TRANS/WP.29/GRSP/2005/3
7 March 2005

Working Party on Passive Safety (GRSP)
(Thirty-seventh session, 23-27 May 2005,
agenda item A.1.)

PROPOSAL FOR A GLOBAL TECHNICAL REGULATION ON
UNIFORM PROVISIONS CONCERNING THE APPROVAL OF VEHICLES WITH REGARD
TO THEIR CONSTRUCTION IN ORDER TO IMPROVE THE PROTECTION AND
MITIGATE THE SEVERITY OF INJURIES TO PEDESTRIANS AND OTHER
VULNERABLE ROAD USERS IN THE EVENT OF A COLLISION

Transmitted by the informal group on pedestrian safety

Figure 6: Impact ~~Point~~point. (*insertion of impact angle example*) (see §3.17. and §3.24.)

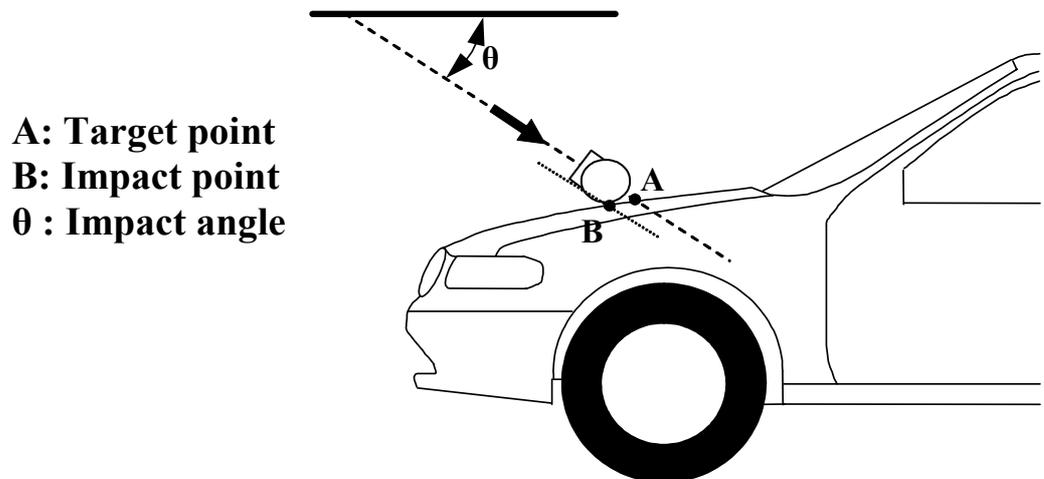
~~*Figure 6 could be used to provide an example of the measured angle.*~~

Figure 13c: Windscreen ~~Lower-lower Reference-reference Line~~line (see §3.33.)
This diagram requires more discussion and agreement.]

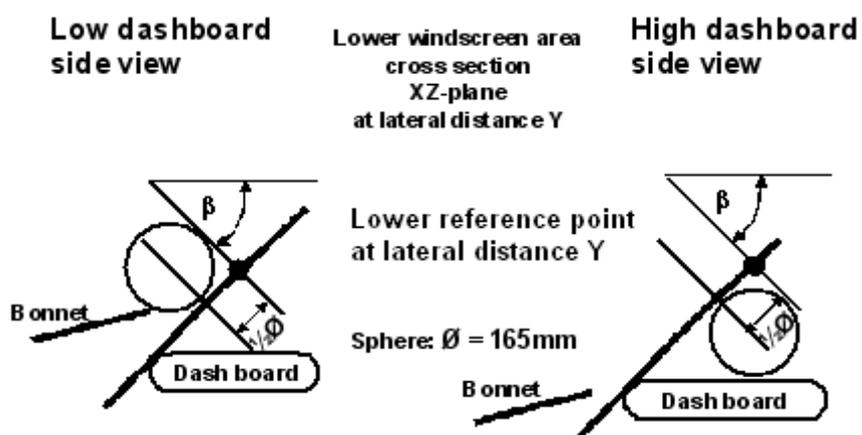
- 3.33. "Windscreen lower reference line (LWL)"
*to be defined, see Figure 13c. **Definition to be proposed by EC.***
- 3.34. "Windscreen side reference line (SWL)" is the trace of all points of intersection between the windscreen and a line which is perpendicular to the transverse plane of the vehicle and maintains a lateral offset of 82.5 mm inside the A-pillars (see Figure 13b).

Bonnet Top Zone A and Bonnet Top Zone B

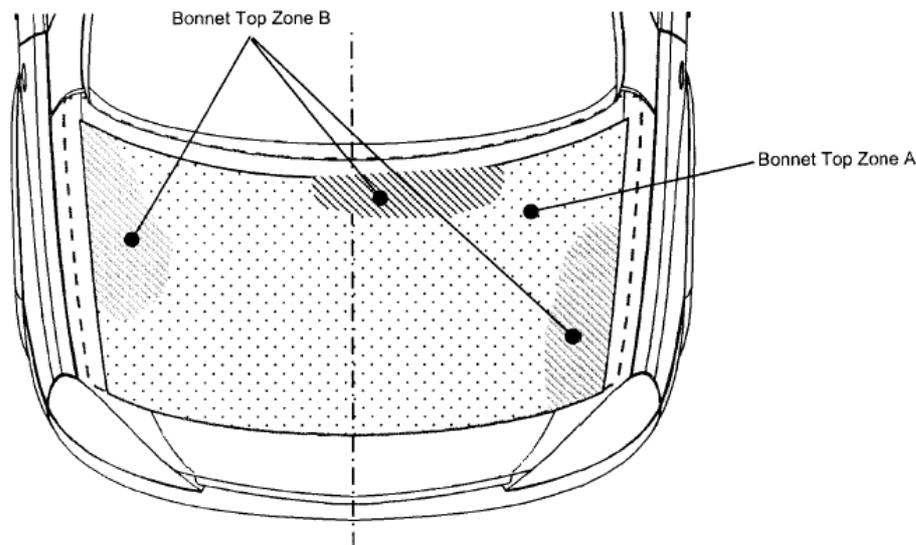
7.2.4.1 The manufacturer shall identify the zones of the bonnet top where the Head Performance Criterion (HPC) must not exceed 1000 (Bonnet Top Zone A) respectively [1700] (Bonnet Top Zone B), according to the technical requirements set out in paragraph 5.2 ~~3.1.2 of Annex I of Directive 2003/102/EC~~ (see Figure X).

7.2.4.2 Marking of the “Bonnet Top” impact area as well as “Bonnet Top Zone A” and “Bonnet Top Zone B” will be based on a drawing supplied by the manufacturer, when viewed from a horizontal plane above the vehicle that is parallel to the vehicle horizontal zero plane. A sufficient number of x and y co-ordinates shall be supplied by the manufacturer to mark up the areas on the actual vehicle while considering the vehicle outer contour in the z direction.

7.2.4.4 The calculation of the surface of the impact area as well as the surface areas of “Bonnet Top Zone A” and “Bonnet Top Zone B” shall be done on the basis of a projected bonnet when viewed from a horizontal plane parallel to the horizontal zero plane above the vehicle, on the basis of the drawing data supplied by the manufacturer.]
